STAR ONLINE PUBLICATION

Case Number: S2008000055

Symptom/Vehicle Issue: Battery Vent Tube Does Not Align With Some New Battery Installations

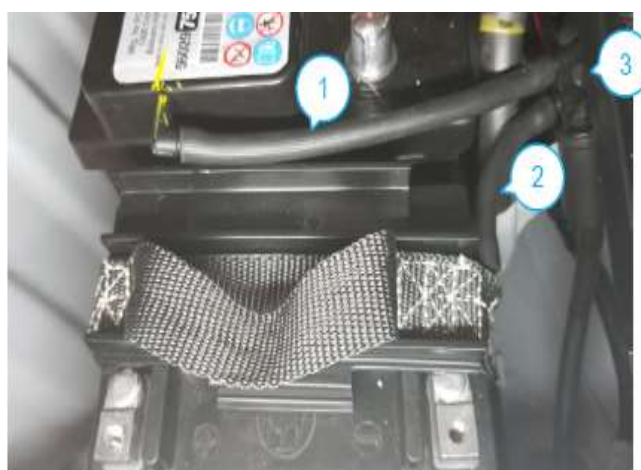
Technician observation: The replacement battery vent tube is not aligned with the original battery vent tube orientation.

Repair Procedure: The OEM elbow and vent tube does not connect with original vent port on auxiliary battery.

New Aux Battery: vent port connectivity solution

- Longer vent tube (1) between AGM starting battery vent port and elbow;
- Longer vent tube (2) between aux battery vent port and elbow; and
- Existing vent tube new position. (3)
